SECTION A-A

OUT FOR APPROVAL	8-23-02																					
OUT FOR APPROVAL																						
ISSUED TO SHOP																						
FIELD & OFFICE																						
REV.	REMARKS	DATE	DWN	CHK	APP	Q.A.	NO.	DIA.	LGT	TYPE	WASHER											
MATERIAL:	M270-50W	ELECTRODES:		HOLES:		SHOP BOLTS:																
SURFACE PREP. & PAINT: -STEEL WITHIN 10'-0" ENDS OF GIRDERS SHALL BE PAINTED (SEE GNI) -ALL OTHER STEEL SHALL BE BLAST CLEANED AND LEFT UNPAINTED.																						
DESCRIPTION:	FLANGE DIAGRAM "C" GIRDERS	DRAWN BY	ATD	DATE	08/07																	
JOB:	VT RTE 9 OVER THE DEERFIELD RIVER	CHKD BY	DO	DATE	08/09																	
	BRIDGE NO. 25	APPROV BY																				
	SEARSBURG, VERMONT	SUPERVISOR	W. J. GATTI																			
	CONTRACTOR: J.A. McDONALD	Q.A.																				
PROJ NO.	PROJ. NHF 010-1(18)																					
CUSTOMER:	VERMONT AGENCY OF TRANSPORTATION																					
CASCO BAY STEEL STRUCTURES, INC.		JOB NO.	165	DRG. NO.	F 4

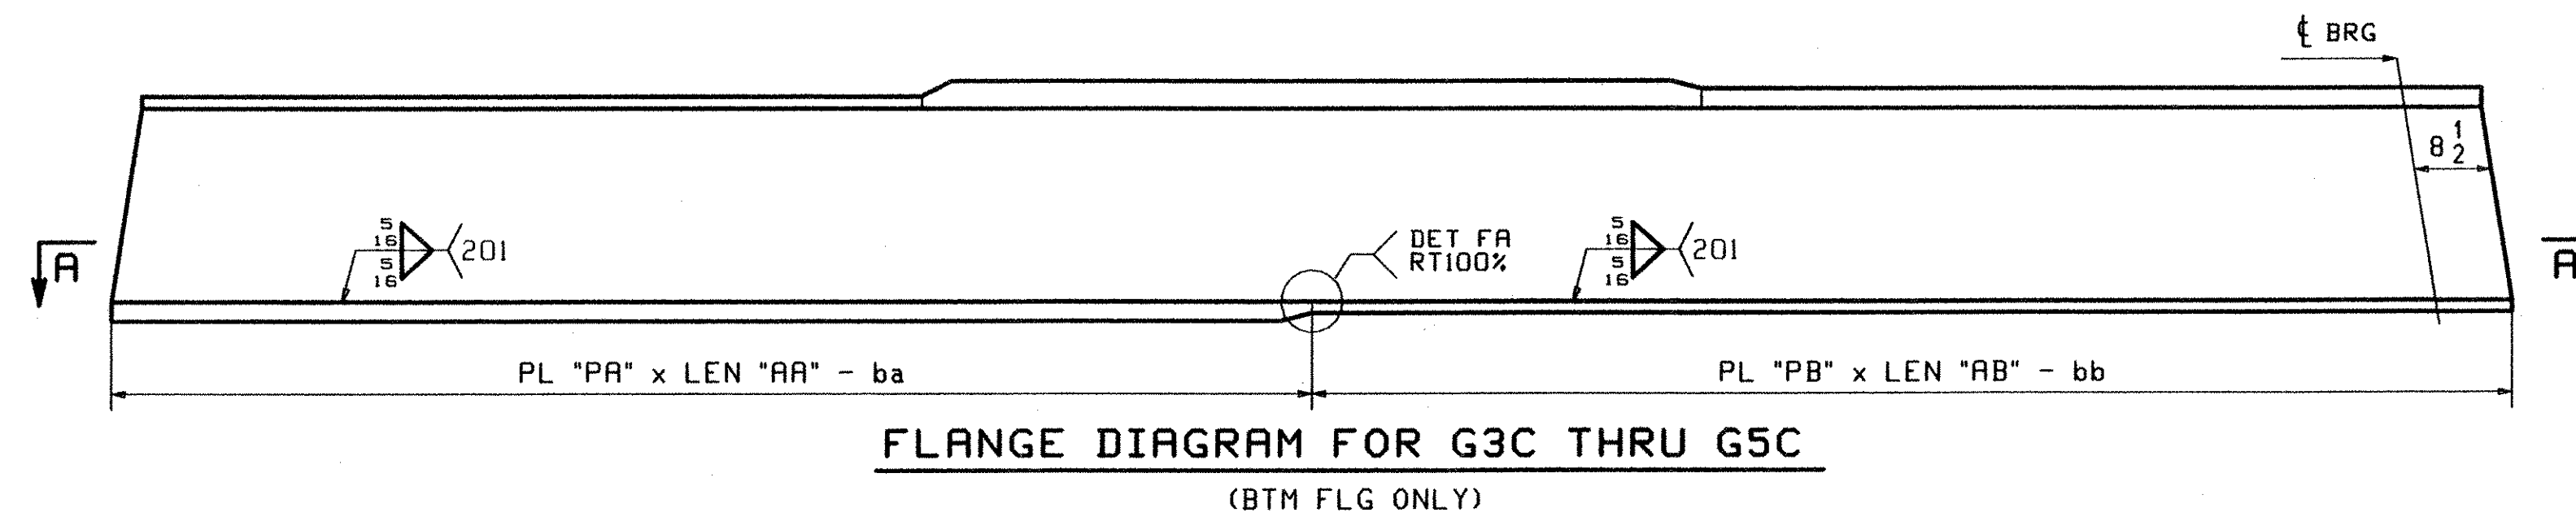
RECEIVED  
 OK'D BY DV OK'D BY \_\_\_\_\_  
 AUG 26 2002  
 RESUBMIT APPROVED ✓  
 BY R24 DATE 9-17-02
